# UNITED STATES PATENT AND TRADEMARK OFFICE

APPLICATION NO.	FILING DATE	FIRST NAMED INVENTOR	ATTORNEY DOCKET NO.	CONFIRMATION NO.
10/552,376	10/07/2005	Hua Chen	H0003955	9276
46507 7590 05/29/2008 HONEYWELL TURBO TECHNOLOGIES 23326 HAWTHORNE BOULEVARD, SUITE #200 TORRANCE, CA 90505				
EXAMINER				
VERDIER, CHRISTOPHER M				
ART UNIT		PAPER NUMBER		
3745				
MAIL DATE		DELIVERY MODE		
05/29/2008		PAPER

### Office Action Summary

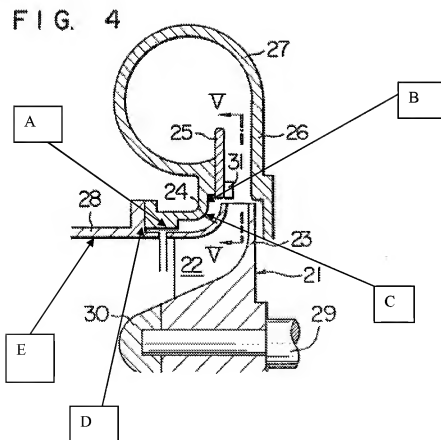
Claims 1, 4, 5, 6, 9, 11, 12/6, 13/6, 14/6, 15/6, 12/9, 13/9, 14/9, 12/4, 13/4, 14/4, 15/1, 15/4, and 15/11 are rejected under 35 U.S.C. 102(b) as being anticipated by Yoshinaga 4,395,197. Disclosed is a compressor comprising a compressor wheel 21 having compressor

blades 22 and being mounted for rotation on a shaft 29, each blade being characterized by an upstream leading edge and a downstream trailing edge, and a shroud 27/28 mounted adjacent the wheel and defining a gas flow path between the shroud and the blades from a compressor inlet to a diffuser outlet, wherein in cross-section the shroud forms a surface A along the flow path, the surface being characterized by a profile that includes a relative discontinuity B in the region of the trailing edge, wherein the discontinuity forms a downstream-facing blocking face adapted to impede an upstream flow of gas between the shroud and the wheel, the blocking face extending across the flow path to form a sharp edge connecting the blocking face to a smoothly curving surface C upstream of the discontinuity. The cross-section profile of the shroud surface along the flow path is further characterized by a second relative discontinuity D that is in the region of the leading edge, wherein the second relative discontinuity forms a second downstream-facing blocking face adapted to impede an upstream flow of gas between the shroud and the wheel, the second blocking face extending across the flow path to form a sharp edge connecting the second blocking face to a second smooth surface E upstream of the second discontinuity. The second discontinuity is located upstream of the leading edge of the wheel blades. The second discontinuity is spaced from the leading edge of the wheel blades by a distance of the same order as the axial clearance of the trailing edge from the compressor housing. The or each downstream-facing blocking face comprises a planar surface cut into the curving surface. The second downstream-facing blocking face comprises a planar surface cut into the curving surface, and the planar surface is perpendicular to the axis of the shaft. The radial extent of the second discontinuity is of the same order as the radial clearance between the trailing edge and the housing. The sizes of the first and second discontinuities are closely similar. The shapes of the

first and second discontinuities are closely similar. Concerning claim 15, the term “turbocharger” is recited in the preamble of the claim and has not been given patentable weight. A preamble is generally not accorded any patentable weight where it merely recites the purpose of a process or the intended use of a structure, and where the body of the claim does not depend on the preamble for completeness but, instead, the process steps or structural limitations are able to stand alone. See *In re Hirao*, 535 F.2d 67, 190 USPQ 15 (CCPA 1976) and *Kropa v. Robie*, 187 F.2d 150, 152, 88 USPQ 478, 481 (CCPA 1951). Note the annotated figure below.

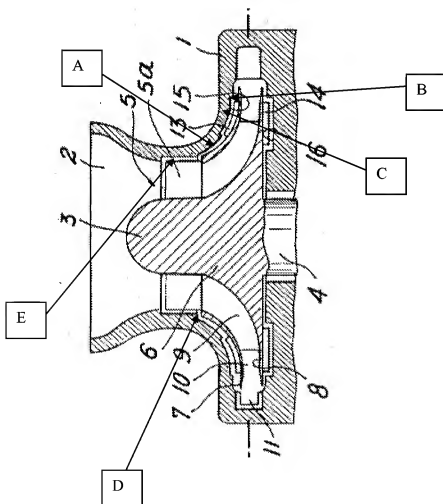
Claims 1, 4, 5, 9, 11, 13/9, 14/9, 13/4, 14/4, 15/1, 15/4, and 15/11 are rejected under 35 U.S.C. 102(b) as being anticipated by Fabri 3,824,029. Disclosed is a compressor comprising a compressor wheel 3/6 having compressor blades 9 and being mounted for rotation on a shaft 4, each blade being characterized by an upstream leading edge and a downstream trailing edge, and a shroud 1 mounted adjacent the wheel and defining a gas flow path between the shroud and the blades from a compressor inlet to a diffuser outlet, wherein in cross-section the shroud forms a surface A along the flow path, the surface being characterized by a profile that includes a relative discontinuity B in the region of the trailing edge, wherein the discontinuity forms a downstream-facing blocking face adapted to impede an upstream flow of gas between the shroud and the wheel, the blocking face extending across the flow path to form a sharp edge connecting the blocking face to a smoothly curving surface C upstream of the discontinuity. The cross-section profile of the shroud surface along the flow path is further characterized by a second relative discontinuity D that is in the region of the leading edge, wherein the second relative discontinuity forms a second downstream-facing blocking face adapted to impede an upstream flow of gas between the shroud and the wheel, the second blocking face extending across the flow path to form a sharp edge connecting the second blocking face to a second smooth surface E upstream of the second discontinuity. The second discontinuity is located upstream of the leading edge of the wheel blades. The or each downstream-facing blocking face comprises a planar surface cut into the curving surface. The second downstream-facing blocking face comprises a planar surface cut into the curving surface, and the planar surface is perpendicular to the axis of the shaft. The

sizes of the first and second discontinuities are closely similar. The shapes of the first and second discontinuities are closely similar. Concerning claim 15, the term “turbocharger” is recited in the preamble of the claim and has not been given patentable weight. A preamble is generally not accorded any patentable weight where it merely recites the purpose of a process or the intended use of a structure, and where the body of the claim does not depend on the preamble for completeness but, instead, the process steps or structural limitations are able to stand alone. See *In re Hirao*, 535 F.2d 67, 190 USPQ 15 (CCPA 1976) and *Kropa v. Robie*, 187 F.2d 150, 152, 88 USPQ 478, 481 (CCPA 1951). Note the annotated figure below.
